# STAR DIODE MATRIX 050907

VK3PE

Sheet:	PICaSTAR SCHEMATICS BY VK3PE & C.S. BASED ON ORIGINALS (C) BY G3XJP
1 of 2	TITLE:- E:\Pnl-2208\Diode Logic Steves\Update 160608\MATRIX_AF-AMP_V-A_050907-PROJ
	For Oct 2007 "VK3PE PCBs" Vers "A"

# G6ALU AUDIO AMP FOR PICaSTAR

## SHEET 1 OF 2

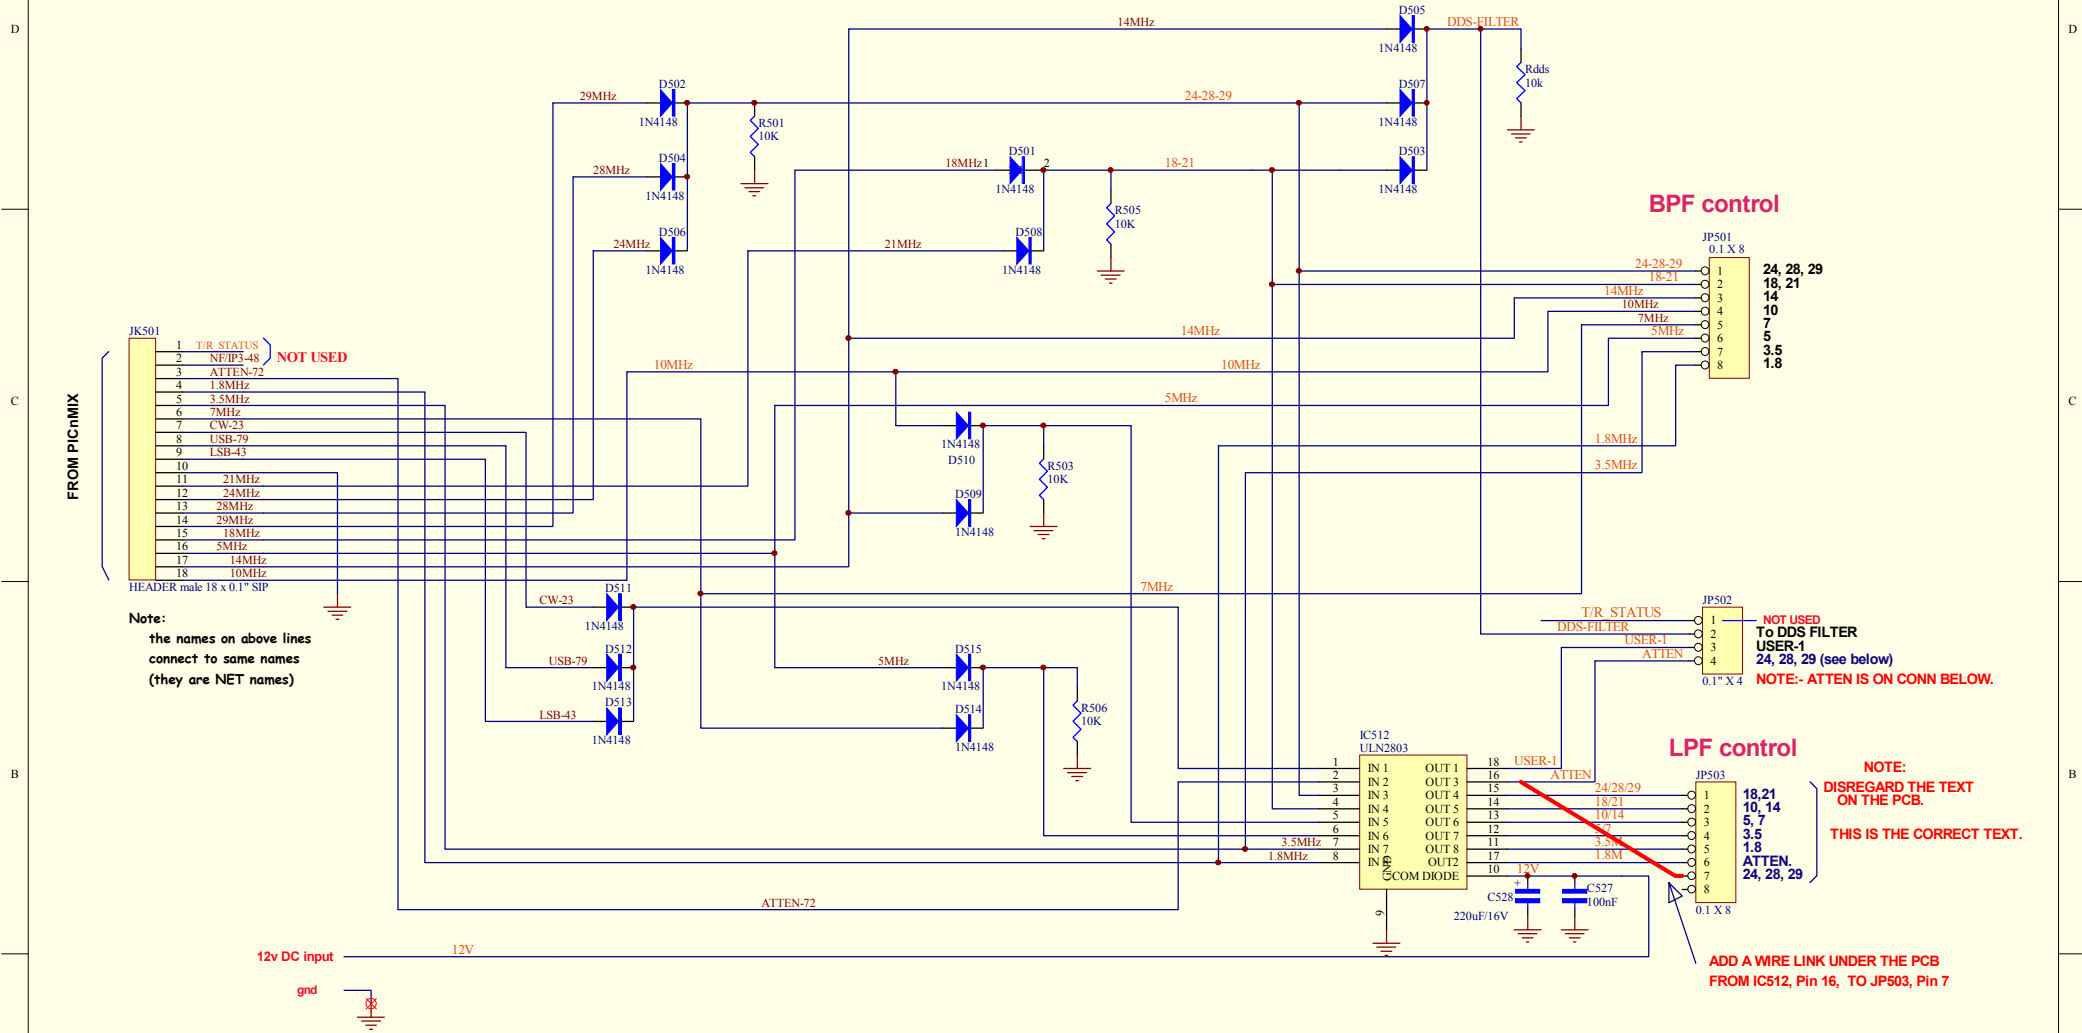
NOTE:  
DISREGARD THE TEXT  
ON THE PCB.  
THIS IS THE CORRECT TEXT.

ADD A WIRE LINK UNDER THE PCB  
FROM IC512, Pin 16, TO JP503, Pin 7

160608 corrected pin name on AF Amp IC.  
5th Dec 2007 Update\_1:- error in LPF control designation

## SHEET 2 OF 2

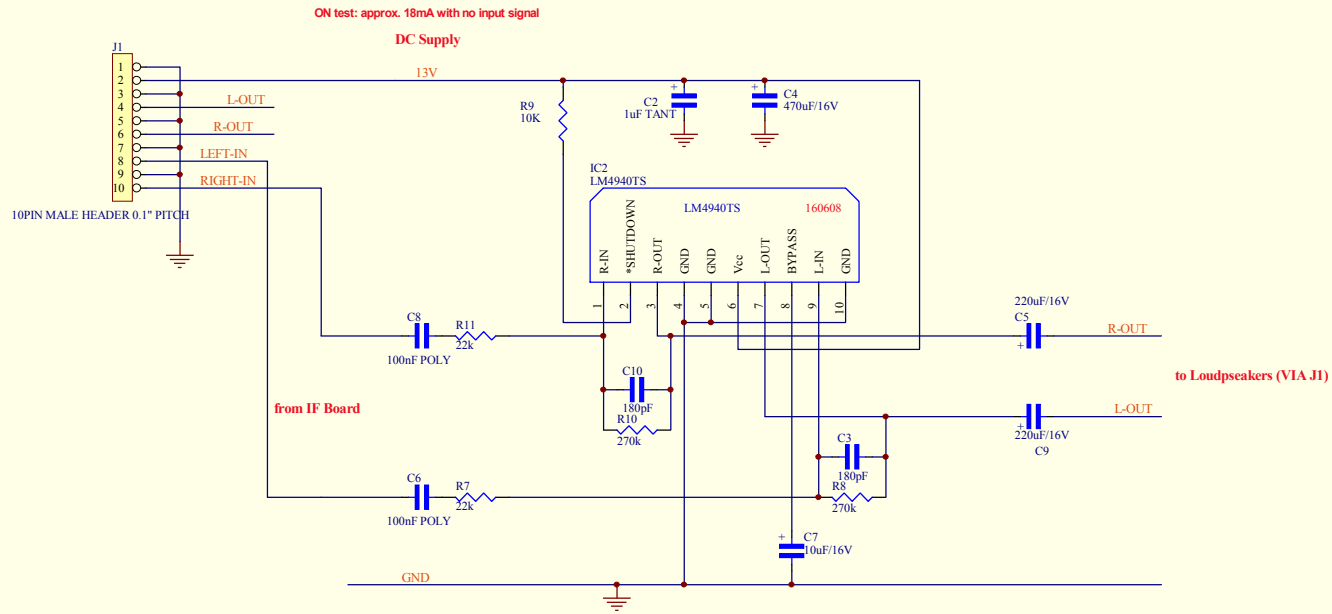
160608 corrected pin name on AF Amp IC.  
05-12-07 Update-1 ADDED CONNECTOR FOR AF AMP.
